# Access Compliance Report

## Public Rights-of-Way

### (Pedestrian Signals)

Intersection ID: N/A	Main Street:	Cross Street: N/A	Location: N/A
ADA ID: 7733BC66F020	Signal Type: One Push Button-Non APS	Overall Compliance: No	Severity Score: BTN 1: N/A BTN 2: N/A No BTN: N/A
Codes/Mitigation Info/Possible Solution		Field Measurements/Component Compliance

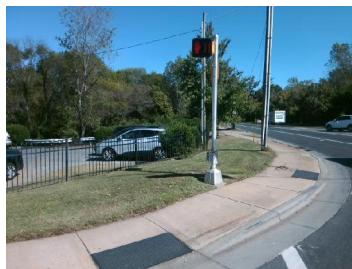
Possible Solutions: Provide PAR As Indicated. Provide Push Button Extension.

PROW/ADA: R209.1, TMUTCD 4e.08, R404.3, R406.2
